LEGACY SUBDIVISION, PHASE TWO & PHASE THREE

Revised for the January 21st, 2010 meeting:

APPLICATION NUMBER 5 DATE January 21, 2010

SITE PLAN

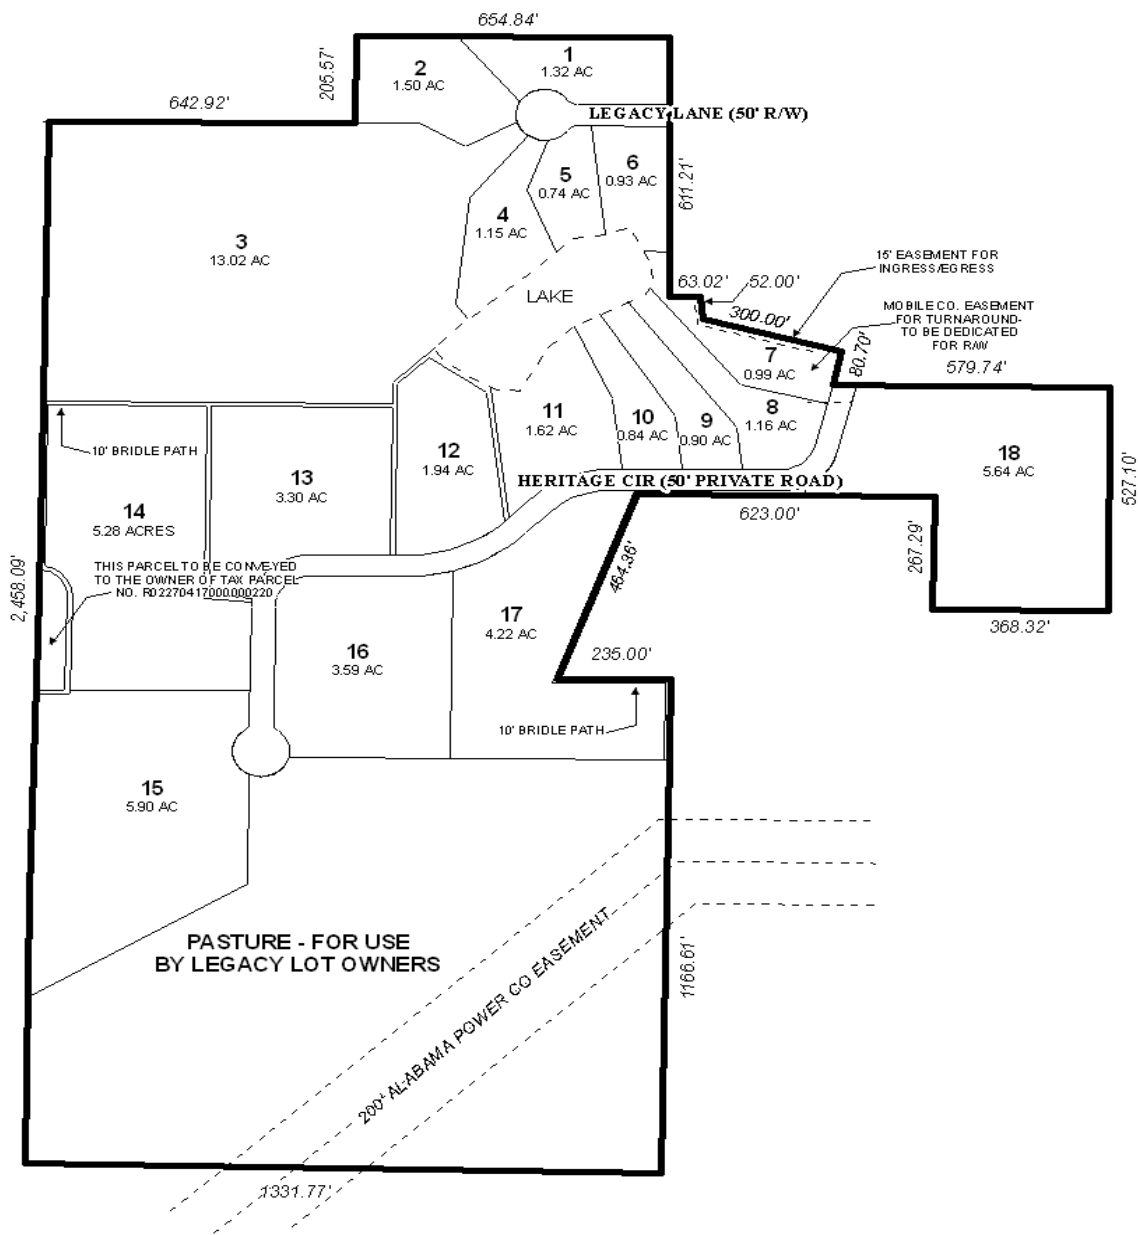
The applicant submitted a revised plat. The applicant is no longer proposing a private gated subdivision as stated in a submitted letter; however, the plat still shows one of the two streets as private. Instead of a 23-lot subdivision, the applicant now proposes 18-lots. Four lots were removed which created a large pasture in the southern portion of the development for the use of the lot owners in Legacy Phases Two & Three.

The subdivision will now be accessed by Legacy Lane and Heritage Circle. Access via Darling Road (a private street) has been removed from the site plan.

As a means of access management, a note should be placed on the plat stating that Lots 1-11 and 17-18 are limited to one curb-cut and Lots 12-16 are limited to two curb-cuts with the size, location, and design to be approved by County Engineering and in conformance with AASHTO standards.

The 25-foot minimum building setback line is not shown, but would be required on the final plat, if approved.

The applicant states that a 60' wide portion at the southwest corner of lot 14 will be conveyed to an adjacent parcel owner (not part of this application) along with an easement for ingress and

egress over Darling Drive that Legacy was conveyed when they purchased the property. It should be noted that conveyance of land must take place through the subdivision process or by inclusion of the parcel with this application. It should also be pointed out that this proposal only addresses one of the land locked parcels adjacent to the proposed subdivision.

Common areas are proposed for the subdivision, including a lake, pasture and bridal paths. All common areas should be labeled, and a note should be placed on the Final Plat, if approved, stating that maintenance of the common areas is the responsibility of the subdivision's property owners.

It should be noted that the subdivision does not comply with Section V.B.6. of the Subdivision Regulations regarding closed-end streets not exceeding 600', thus a waiver will be required, if approved. The approximate length of Heritage Circle is 1,880'.

This application is recommended for denial for the following reasons:

- 1) Conveyance of land is not allowed without subdivision application and must include the adjacent parcel;
- 2) Land-locked parcels adjacent to site were not addressed, per Section VIII.E.1.b.; and
- 3) Cul-de-sac length exceeds the recommended maximum length, per Section V.B.6.
